UNITED STATES OF AMERICA  
NUCLEAR REGULATORY COMMISSION

ADVISORY COMMITTEE ON REACTOR SAFEGUARDS  
SUBCOMMITTEE ON REACTOR RADIOLOGICAL EFFECTS

13 The purpose of this meeting is to discuss the  
14 accident fission product source term, particularly for  
15 iodine, used in the regulatory process for designing, siting  
16 and planning for emergencies at nuclear power plants. As  
17 most of you know, there has been considerable discussion,  
18 both technically and in the public domain, on this subject  
19 in the past few months, and as a result of these inquiries  
20 and questions that have been raised, the Nuclear Regulatory  
21 Commission has initiated the preparation of a State of  
22 Technology Report on Fission Product Iodine, and their  
23 objective in asking that this report be prepared is to  
24 provide the Commission with the best available technical  
25

Figure 8. Typical Iodine Distribution Within Containment Vessel.  
Neg. 8012554-7

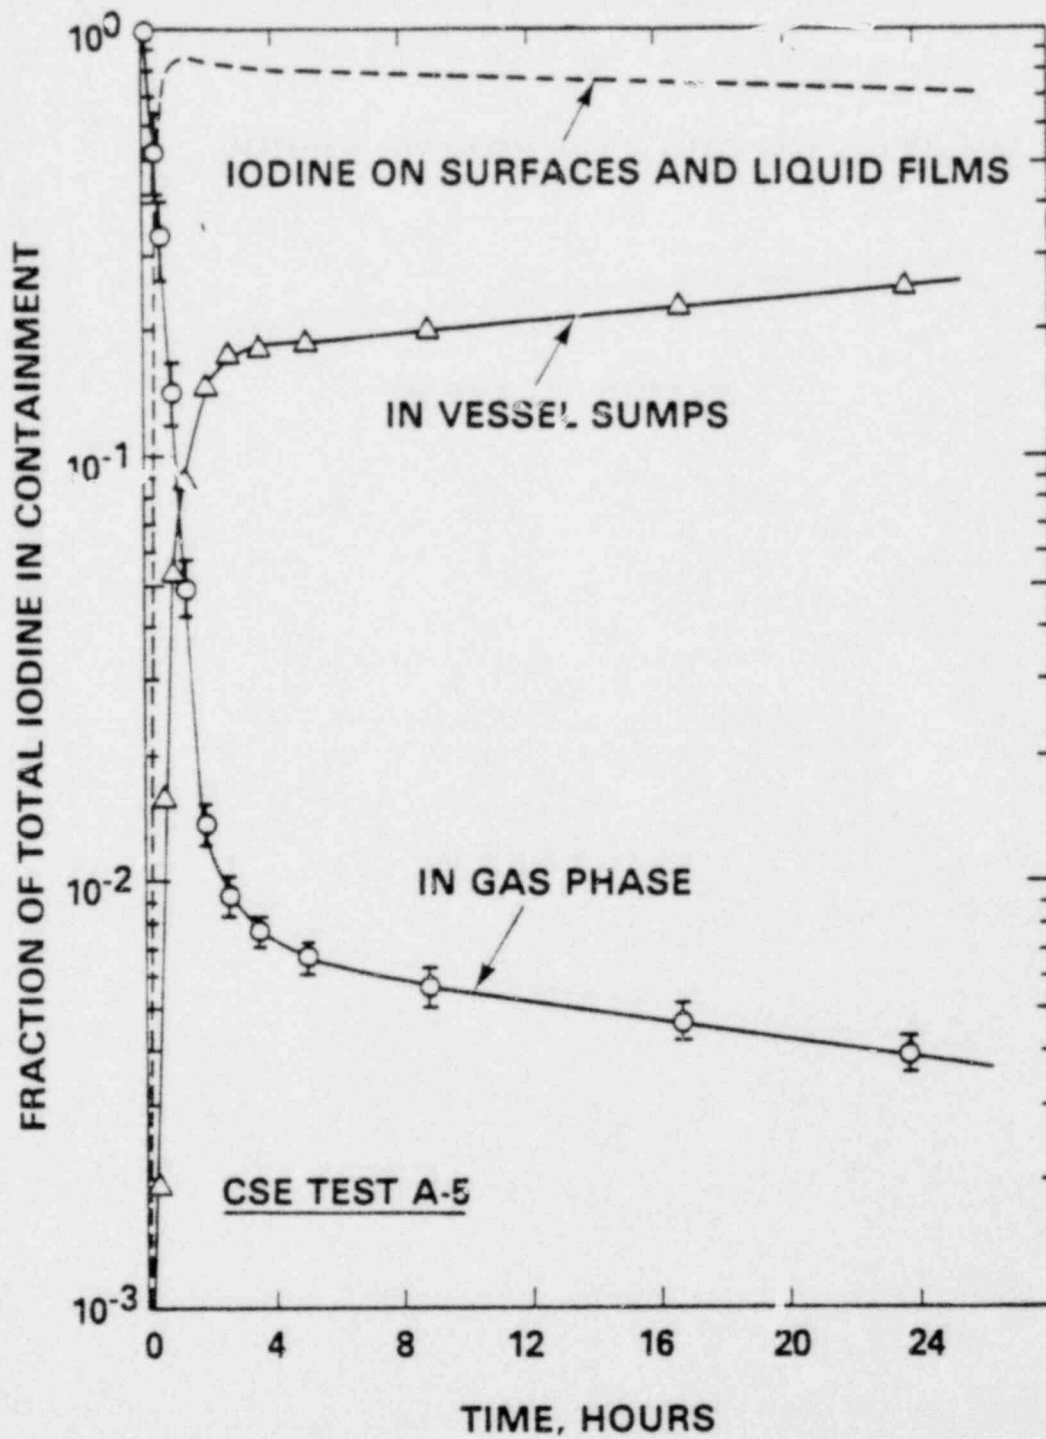
5 MR. LAWROSKI: You told me that this was not by  
6 difference. Getting back to your figure 8, either when this  
7 is Xeroxed the data points disappeared -- but I see no data  
8 points.
